CITY of NOVI CITY COUNCIL

SUBJECT: Approval of a Storm Drainage Facility Maintenance Easement Agreement from Shastco, LLC, for the project located on Roethel Drive south of Nine Mile Road (parcel 22-35-127-018).

RE: Shastco Truck Well – Storm Drainage Maintenance Agreement

RE: **Truckwell (22285 Roethel Drive), JSP14-26**
City of Novi, Oakland County, Michigan

PROJECT NUMBER
14040
 SHEET NUMBER
C-4

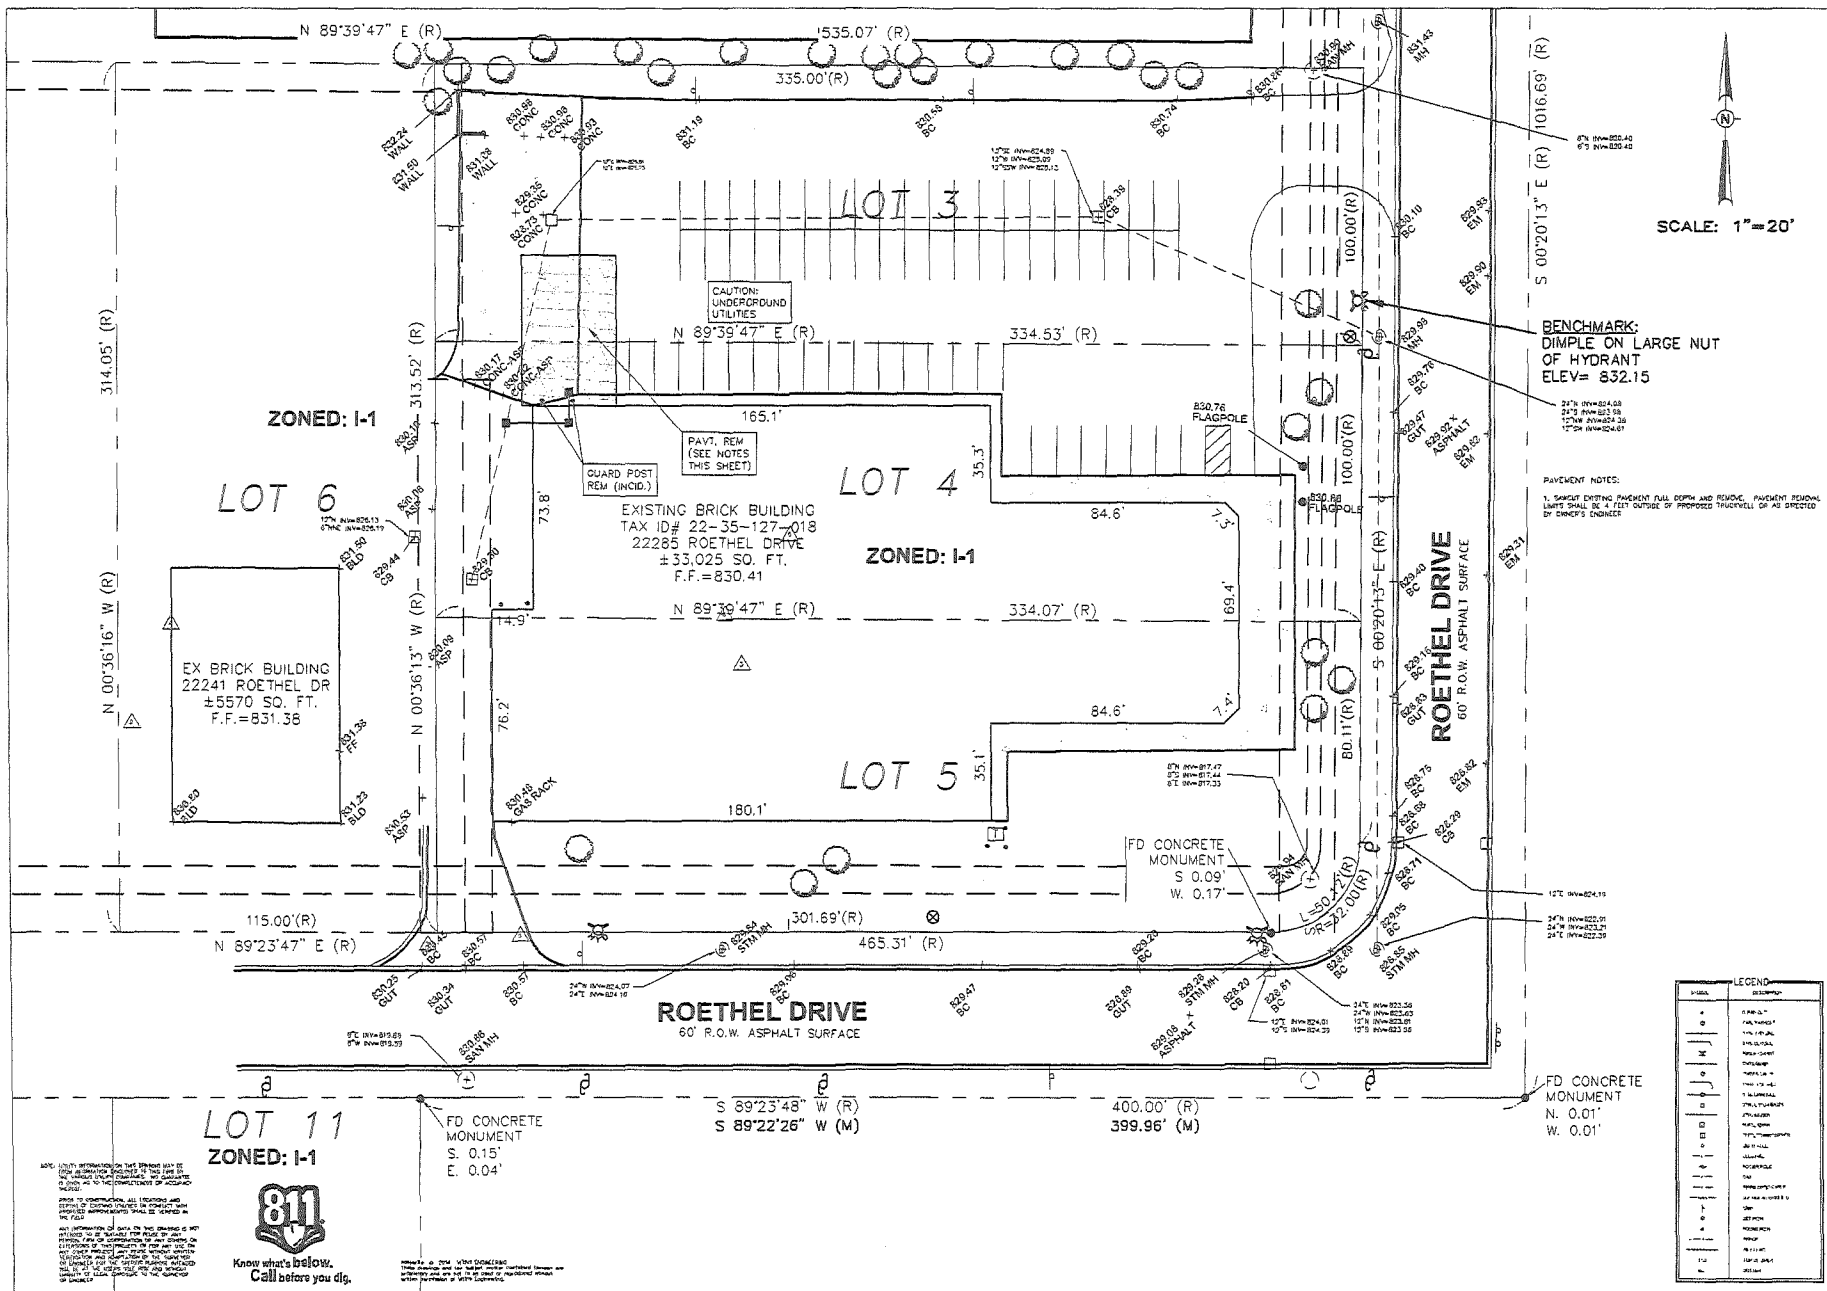
- ✓ 5. Pump station details are included on Sheet C-7.
- ✓ 6. Storm sewer profile is shown on Sheet C-4.
- ✓ 7. Upstream and downstream inverts are provided for Catch Basin 1.
